# Service bulletin concerning corrosion to pre-2019 VZ jib

DOCUMENT NUMBER 1035377

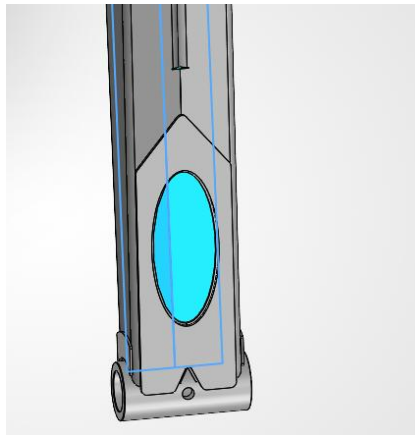
Two cases of severe corrosion have been reported in VZ machines manufactured in 2015 and 2016. The corrosion has occurred on the inside of the lower face of the jib. This area should therefore be checked carefully with cases of significant corrosion being investigated further. The faces highlighted in blue show the area of concern.

In 2019, this design was changed to include a large elliptical hole in the lower face, as well as the upper face. Post 2019 models are therefore less susceptible to corrosion in this area because of the greater thickness of structural material.

This issue concerns any VZ with an elliptical hole only on the top face of the jib. This corresponds to serial numbers 13417 to 14849.

Pre-operation checks should always include checks for deterioration, but operators are asked to focus on this particular area, and report any concern. If water has been collecting in this area, the remaining thickness of the steel on the lower face of the jib should be checked. Contact Aldercote for assistance if necessary.
